# Access Compliance Report

## Public Rights-of-Way

### (Pedestrian Signals)

Intersection ID: N/A	Main Street:	Cross Street: N/A	Location: N/A
ADA ID: C14E69B4C214	Signal Type: One Push Button-Non APS	Overall Compliance: No	Severity Score: BTN 1: N/A BTN 2: N/A No BTN: N/A
Codes/Mitigation Info/Possible Solution		Field Measurements/Component Compliance

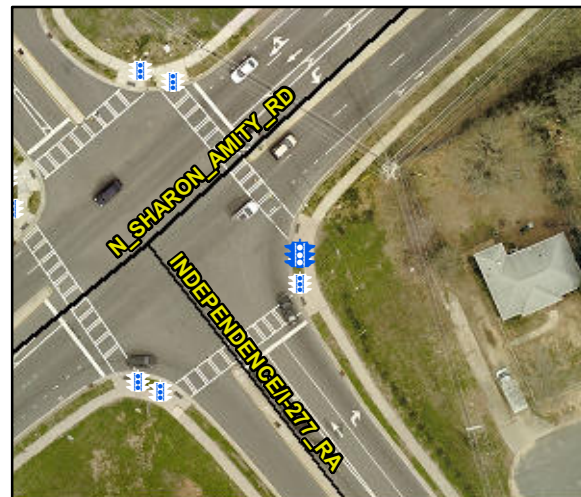
Possible Solutions: Provide Push Button Extension. Remove and Replace Clear Space.

PROW/ADA: R404.2, R404.3, R406.2
